PCN#20200904000.1 Qualification of HFTF as an additional assembly site for select Devices Change Notification / Sample Request

Date:September 09, 2020To:SFO TECHNOLOGIES PCN

PCN Number: 20200904000.1			PCN			Date:	Sept 09, 2020	
Title: Qualification of HFTF as an additional assembly site for select Devices								
Customer Contact: PCN Manager		<u>Manager</u>	Dept: Quality Services					
Proposed 1 st Ship Date: Dec		Dec 09, 2	Dec 09, 2020 Esti		Estim	nated Sample Availability:		Date provided at sample request
Change Type:								
Assembly Site			Design			Wafer Bump Site		
Assembly Process			Data Sheet			Wafer Bump Material		
Assembly Materials			Part number change			Wafer Bump Process		
Mechanical Specification			Test Site			Wafer Fab Site		
Packing/Shipping/Labeling			Test Process			Wafer Fab Materials		
Wafer Fab Process								
PCN Details

Example:

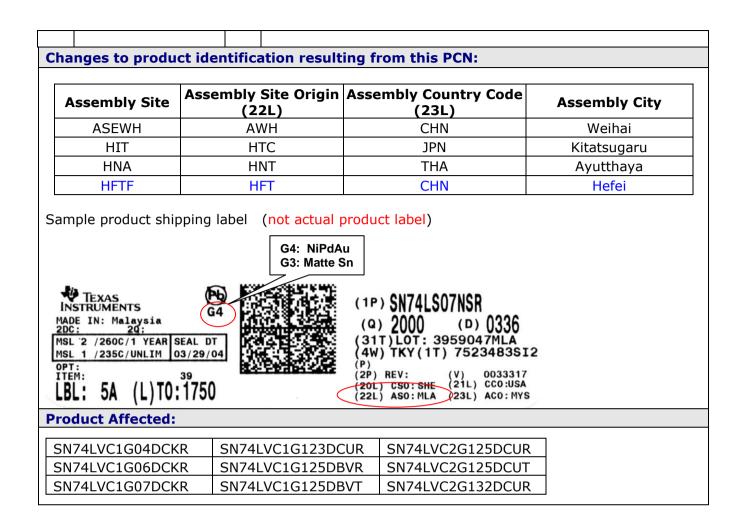
Upon expiry of this PCN TI will combine lead free solutions in a single <u>standard part number</u>, for the devices in group 2. For example; <u>SN74LVC1G04DCKR</u> – can ship with both Matte Sn and NiPdAu. When available customers may specify NiPdAu finish by ordering the part with the G4 suffix, e.g. **SN74LVC1G04DCKRG4**."

Customer order for 7500 units of *SN74LVC1G04DCKR* with 2500 units SPQ (Standard Pack Quantity per Reel).

- TI can satisfy the above order in one of the following ways.
 - I. 3 Reels of NiPdAu finish.
 - II. 3 Reels of Matte Sn finish
 - III. 2 Reels of Matte Sn and 1 reel of NiPdAu finish.
 - IV. 2 Reels of NiPdAu and 1 reel of Matte Sn finish.
